DRB Feedback

FILE: KIRKLAND URBAN EAST, DRV21-00535

Massing Option 3 (Preferred)

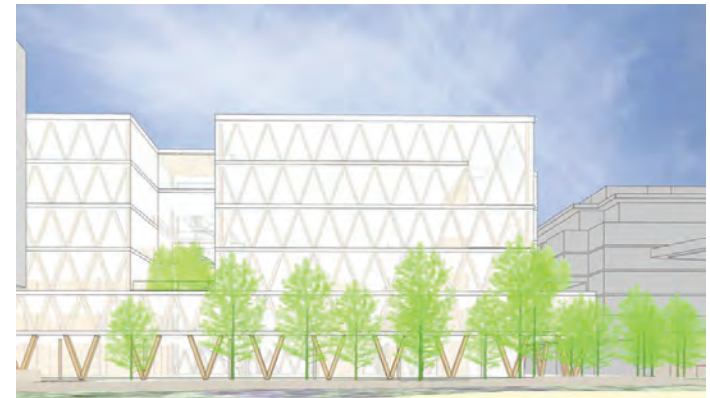
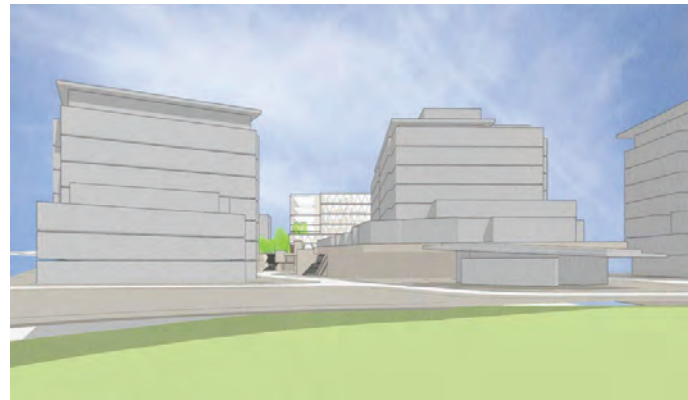
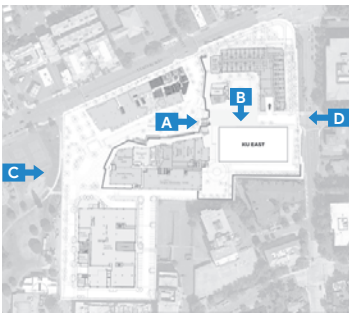
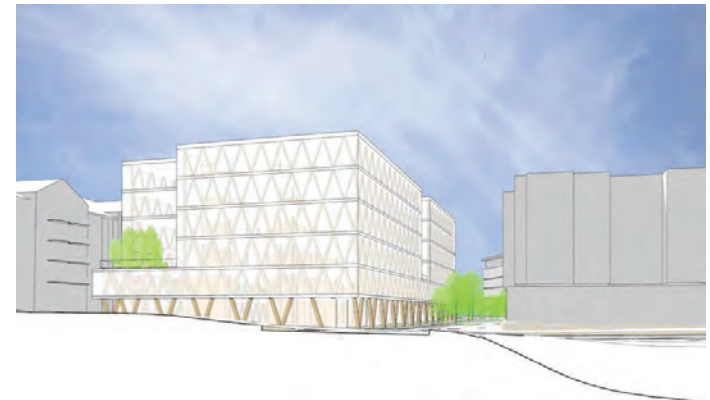
The DRB members also requested to see detailed landscape plans to better understand the relationship between the building massing and the landscape, including the following drawings / visualizations:

- **Detailed plans for any pedestrian sidewalks or walkways.**
[Click Here](#)
- **Street section** drawings showing adjacent street/ access roads and buildings.
[Click Here](#) & [Here](#)
- **Detailed plans for the fire lane and landscaping** along the south property line.
[Click Here](#)
- **Detailed plans for the area near the daycare use.**
[Click Here](#)
- **Views of the South side of the building** to show the relationship to adjacent buildings.
[Click Here](#)
- **Facade Development** to show how the building relates to the campus as a whole.
[Click Here](#)
- **Rooftop Visualization**
[Click Here](#)

Massing Option 3

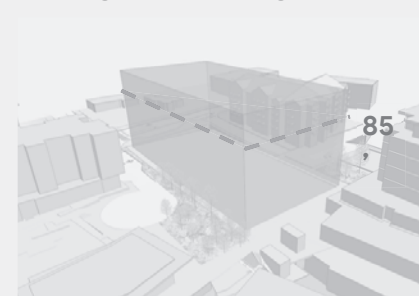
The DRB expressed a preference for **Massing Option 3** (the applicant's preferred plan).
